**ADDENDUM #3  
TO THE  
SPECIFICATIONS AND CONTRACT DOCUMENTS  
FOR**

**Camas TO4 Ultraviolet Disinfection Replacement  
City Project No. SWR25004**

May 16, 2025

**SHEET**  
**003X-301**

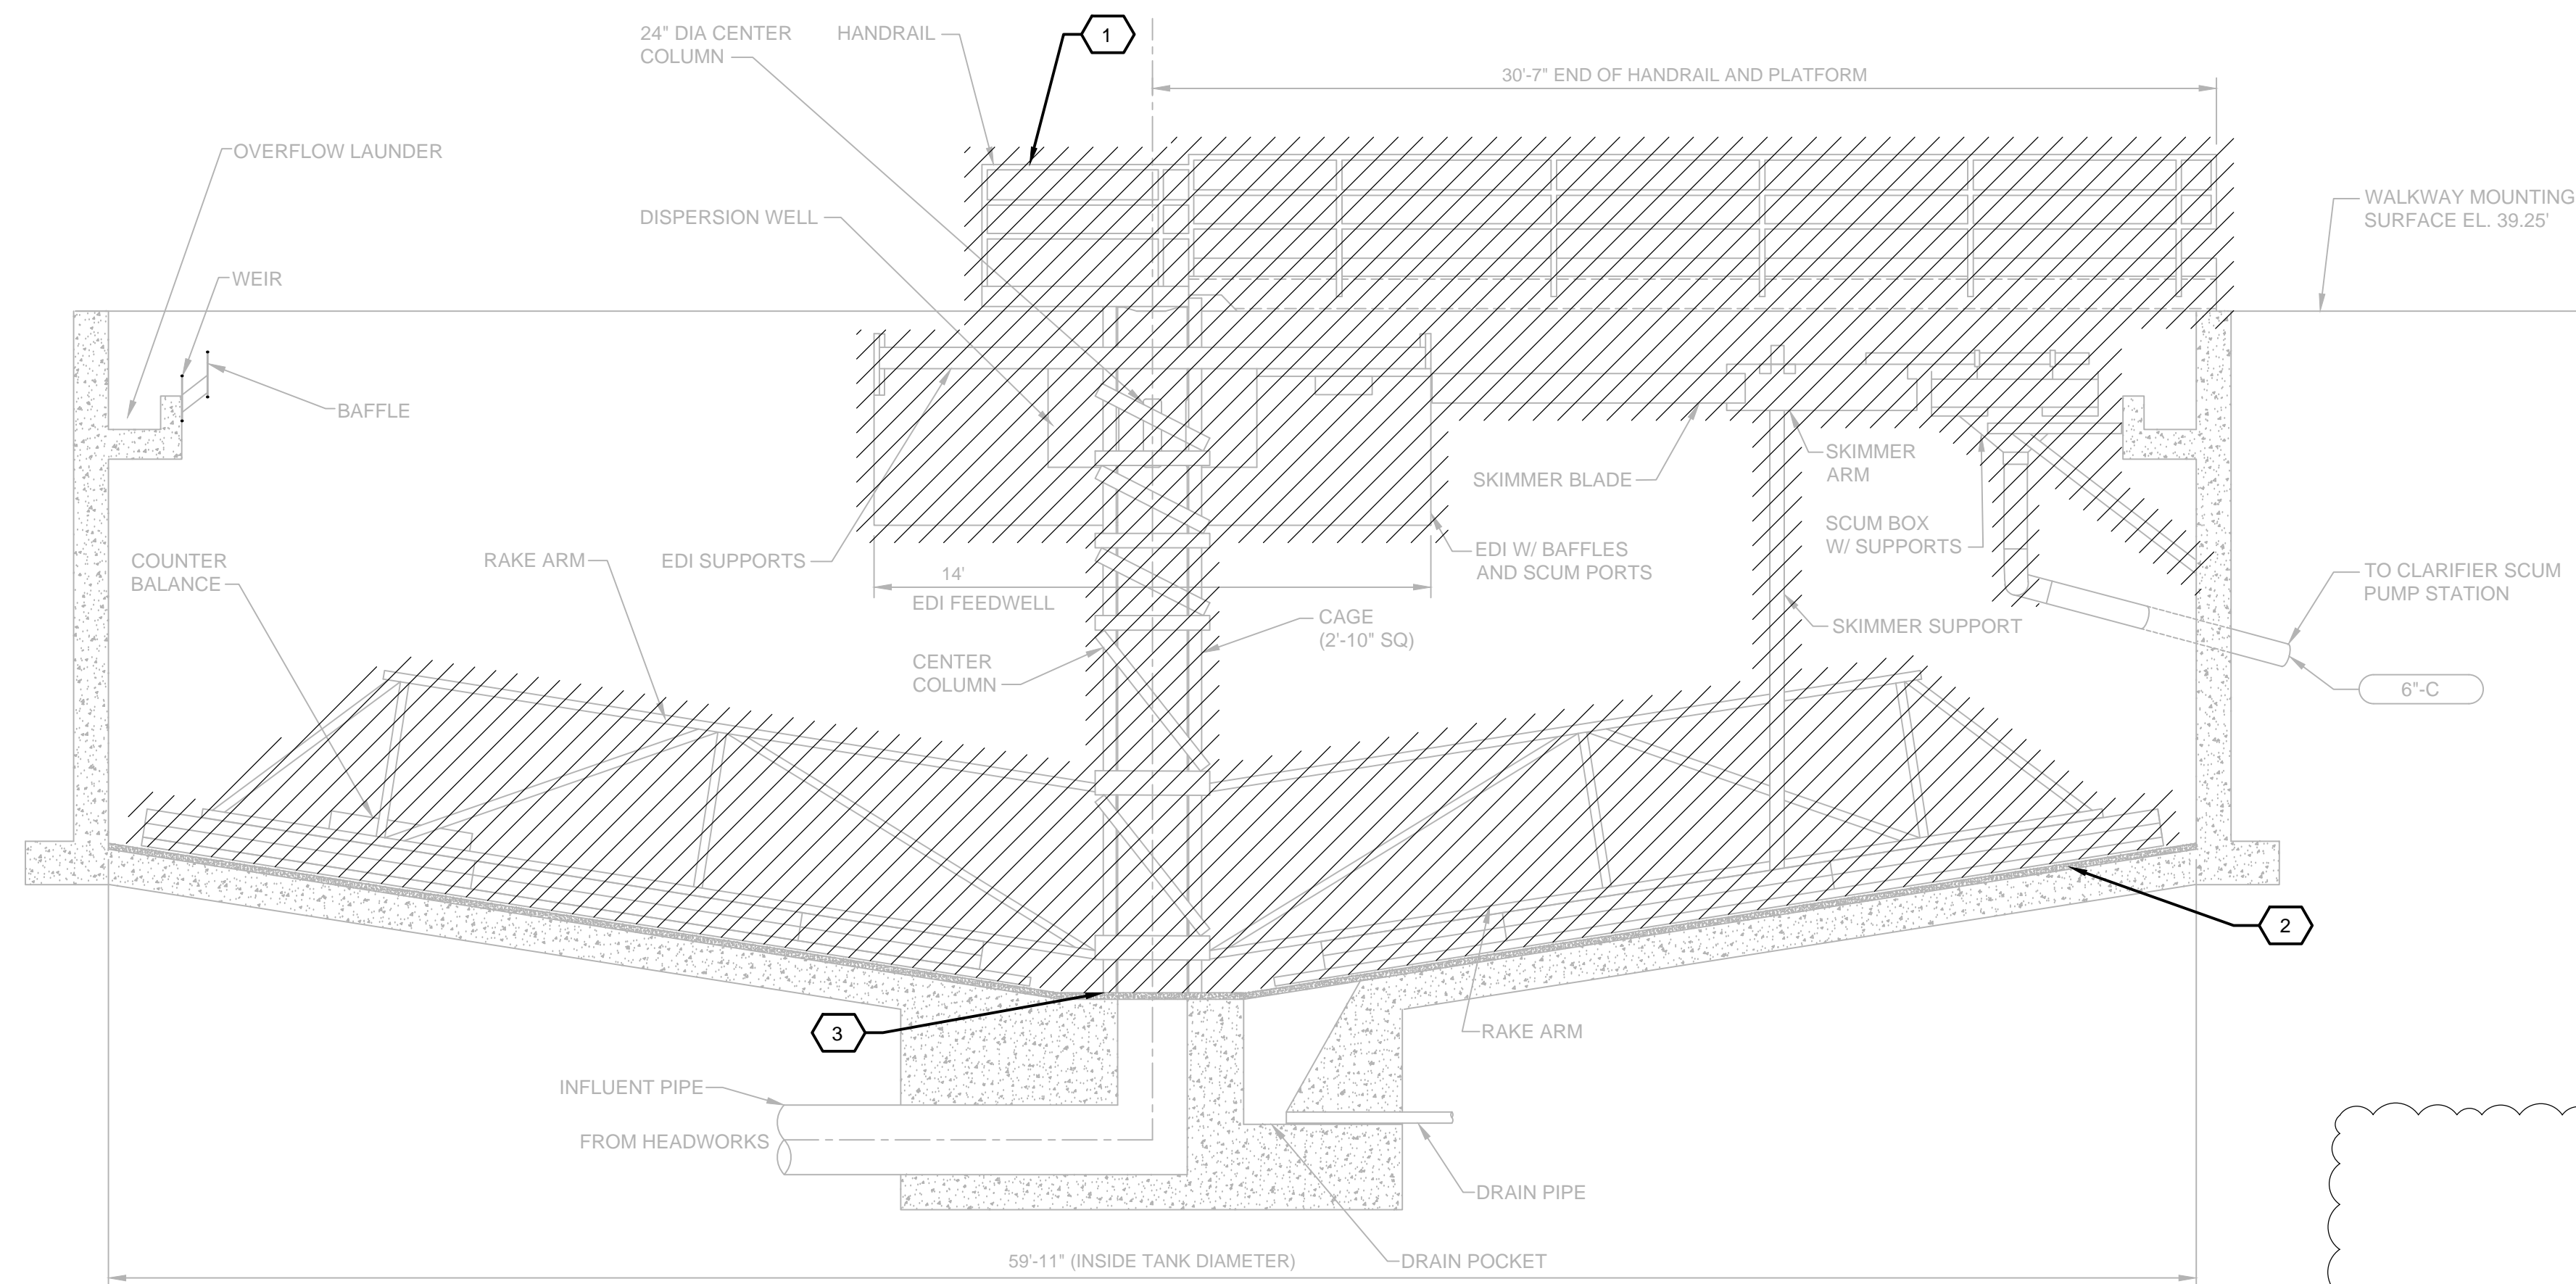
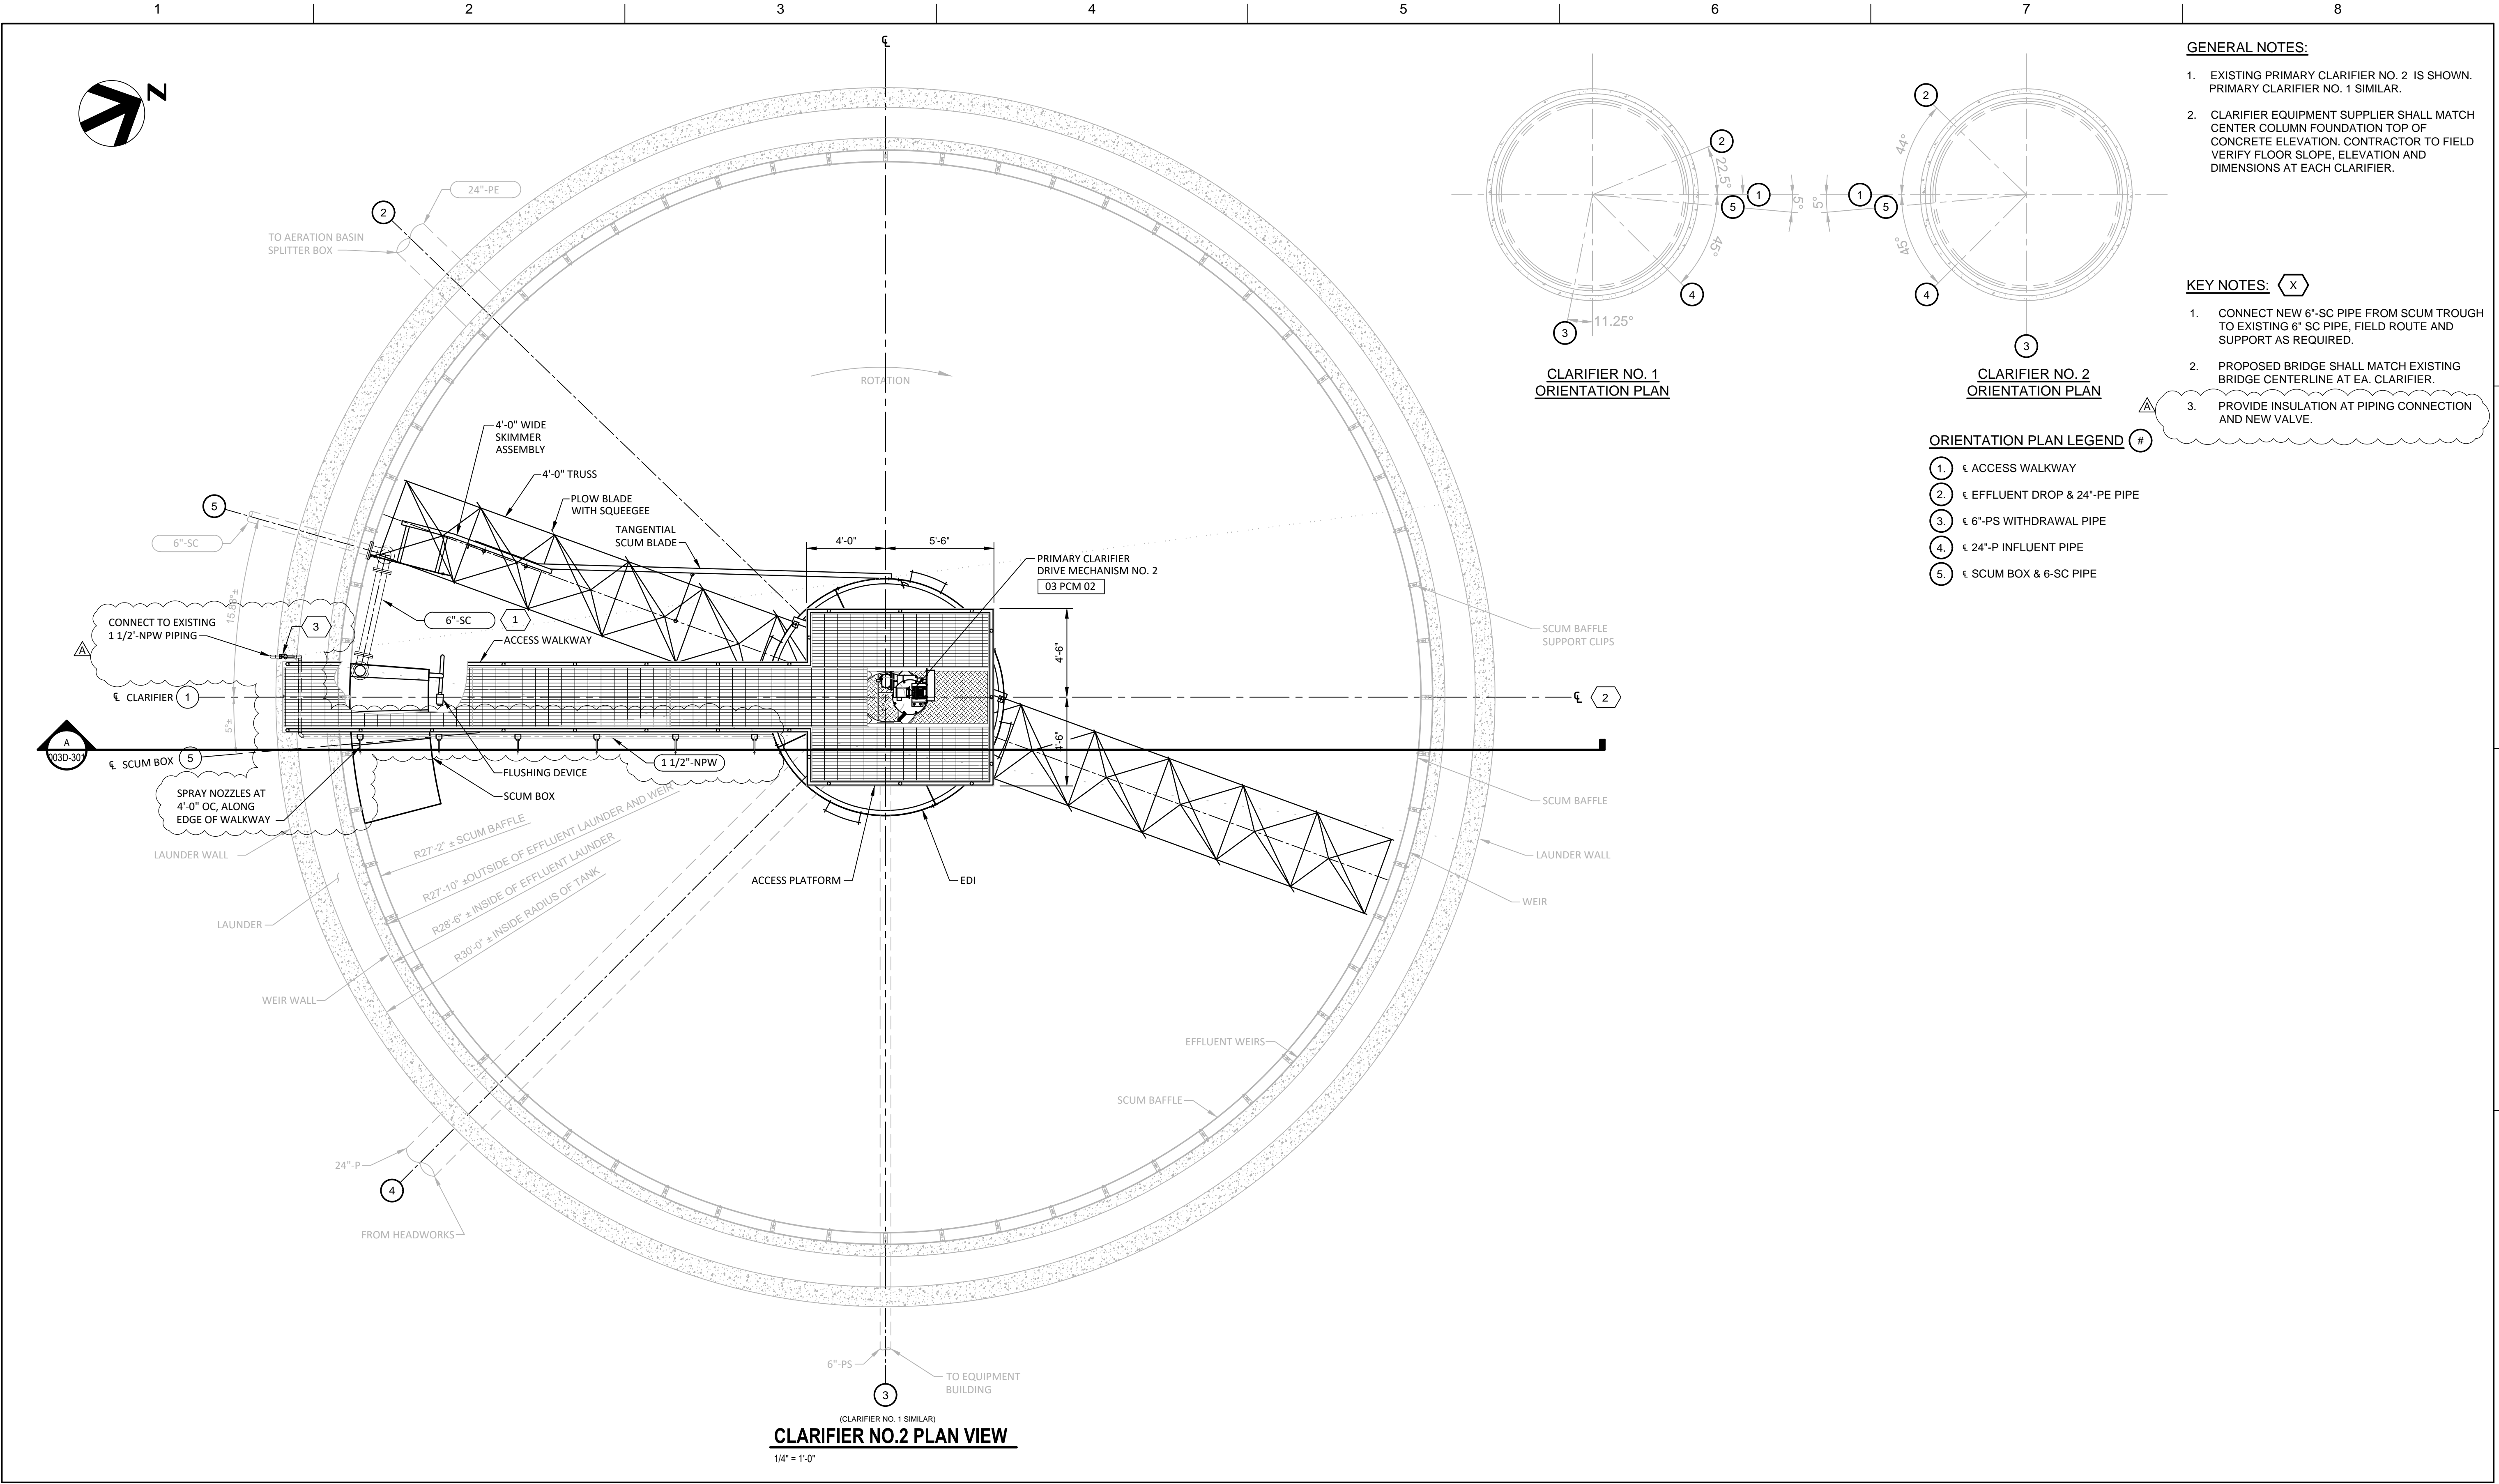
- A. Summary of change: Updated drawing to show a photo detail of the demolition extents of the existing spray bar and NPW piping. Removed the water surface elevation. Water surface elevations should be reference using the hydraulic profile in the drawings.

SHEET  
003D-101

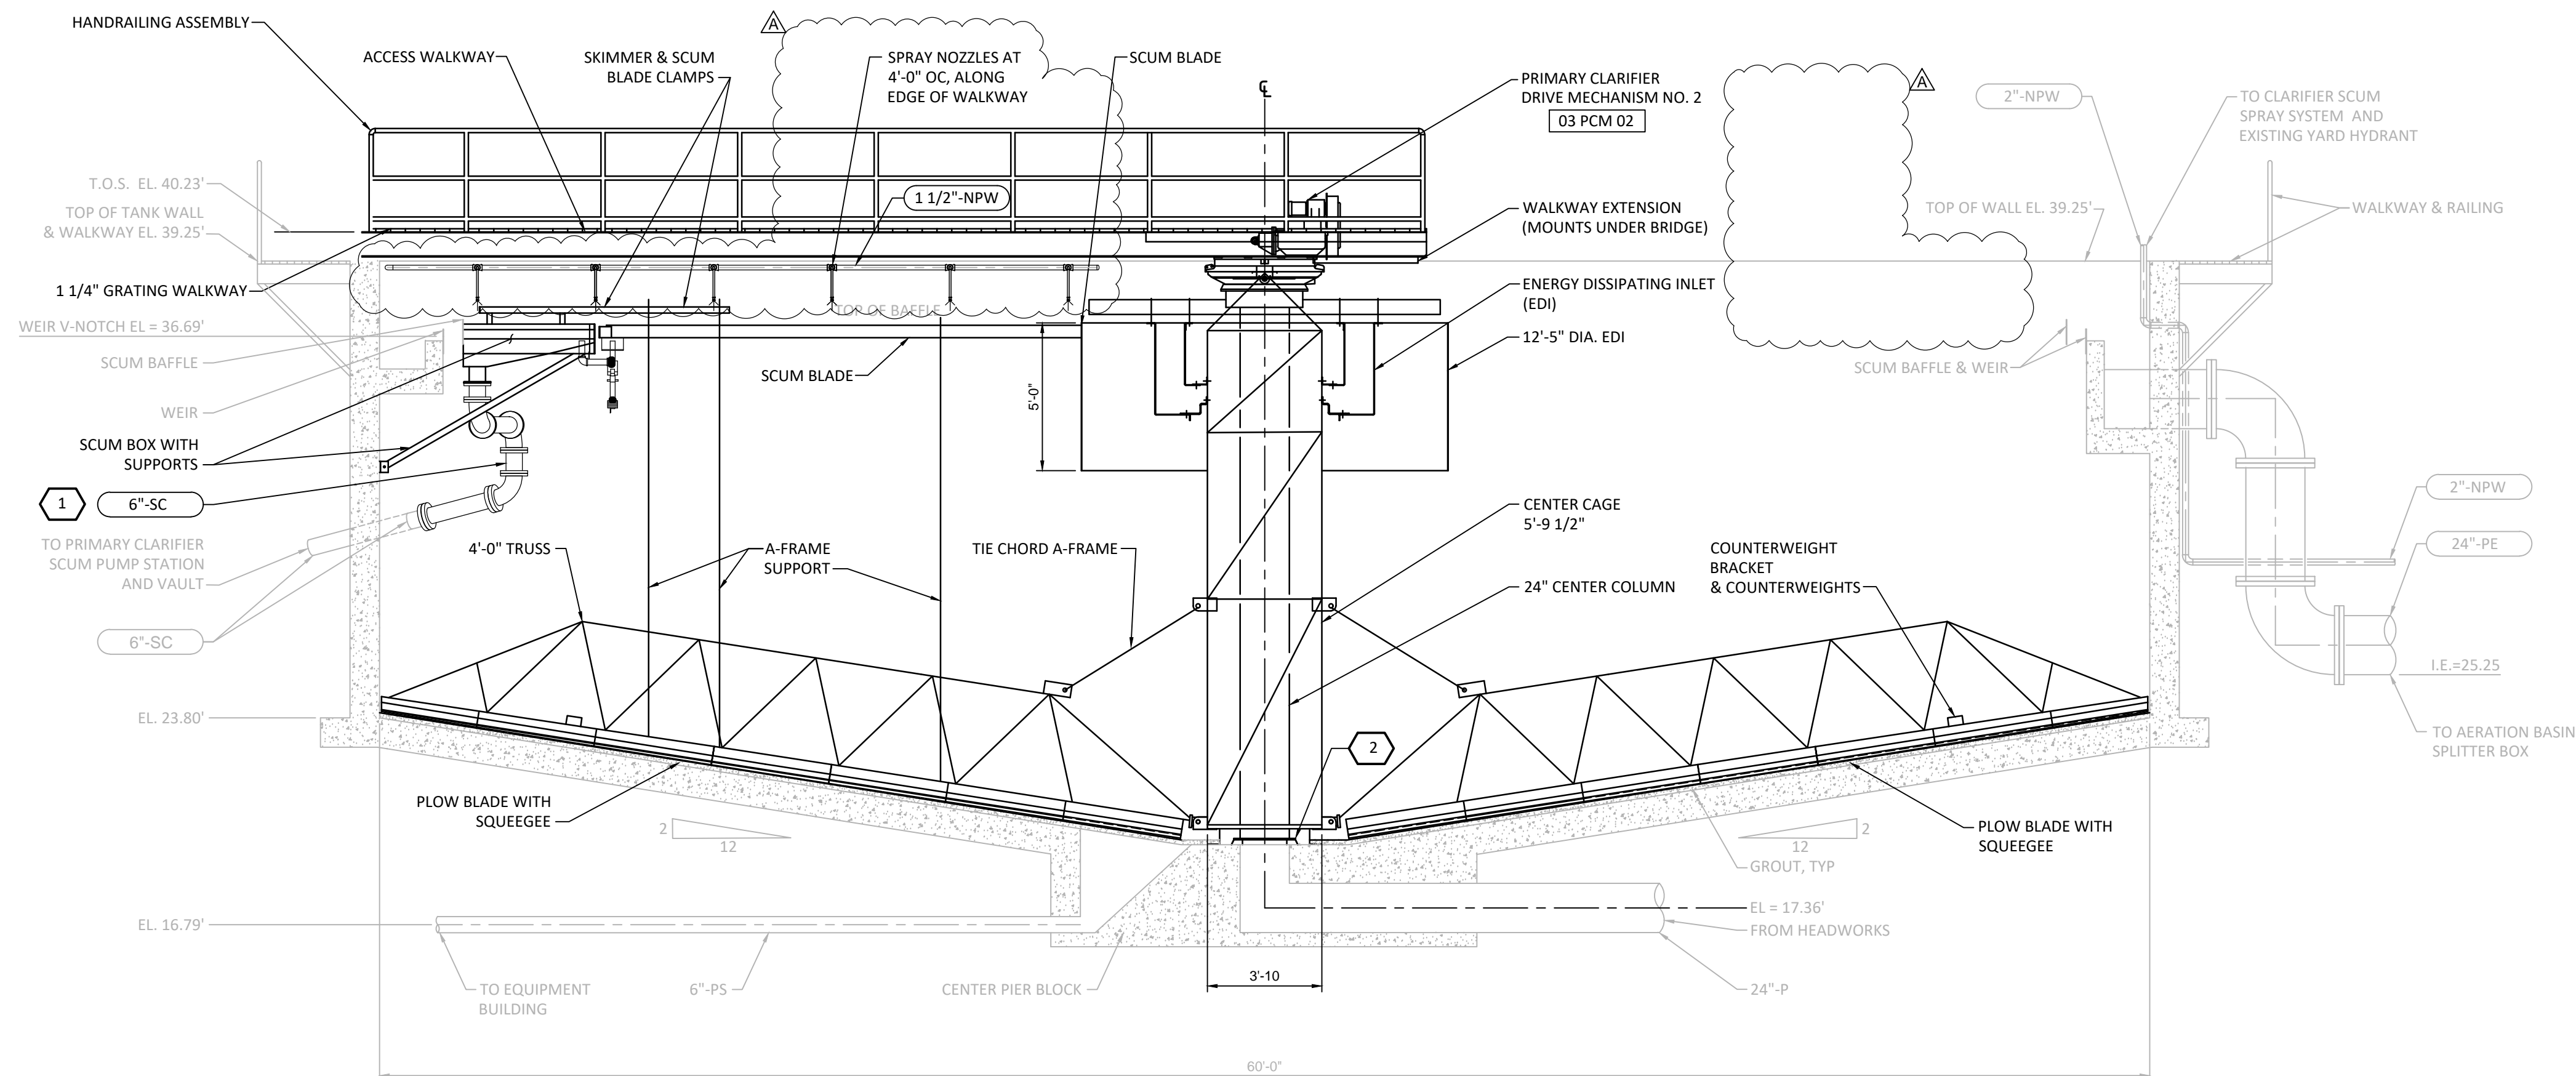
- A. Summary of change: Updated drawing to show sprayers and spray control needed at the new clarifiers. These will be controlled by a manual valve, similar to the existing spray system.

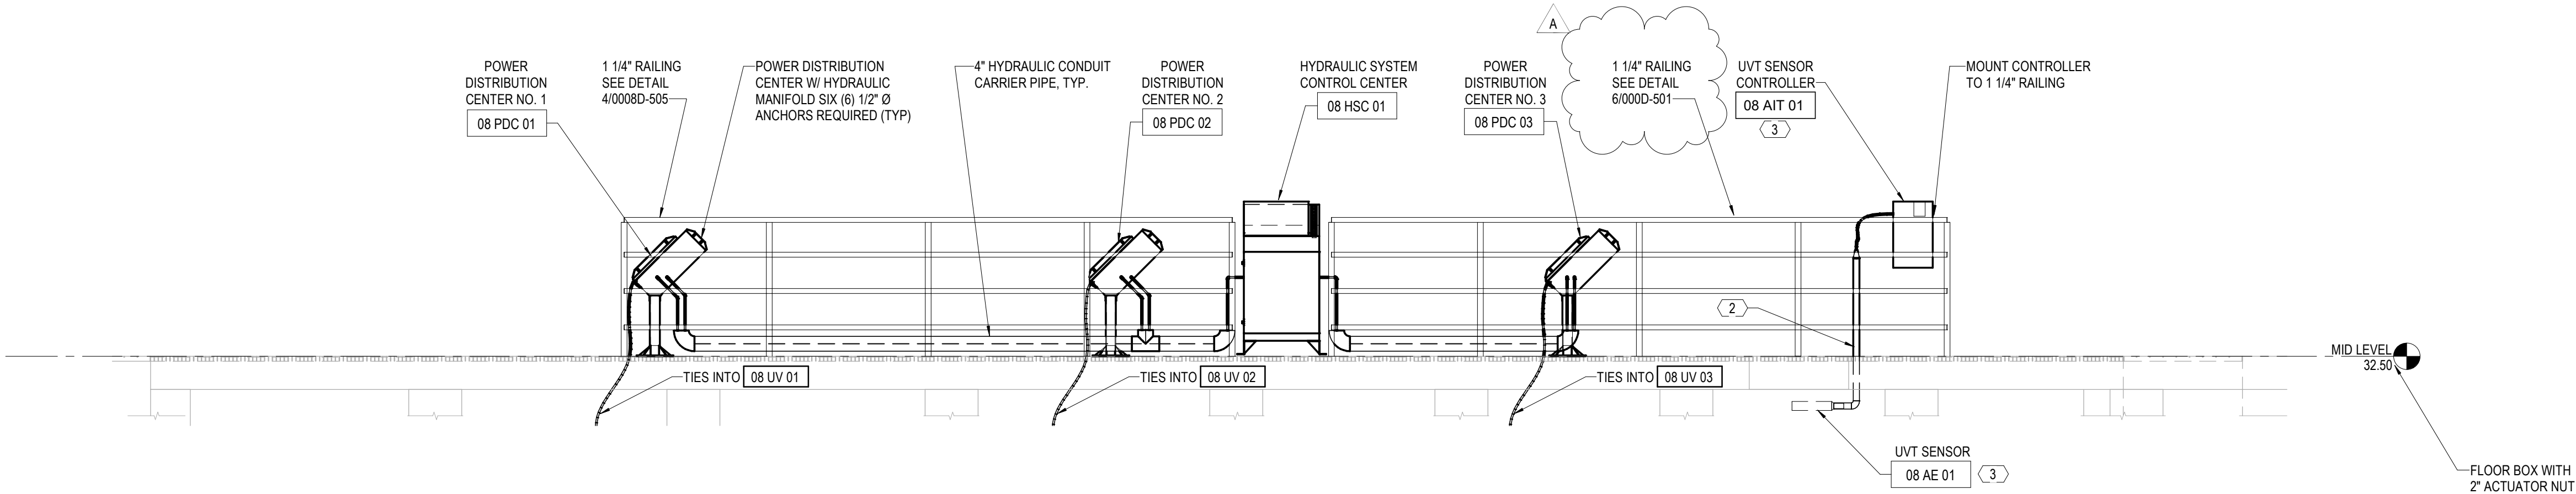
- A. Summary of change: Updated drawing to show correct railing detail sheet reference.
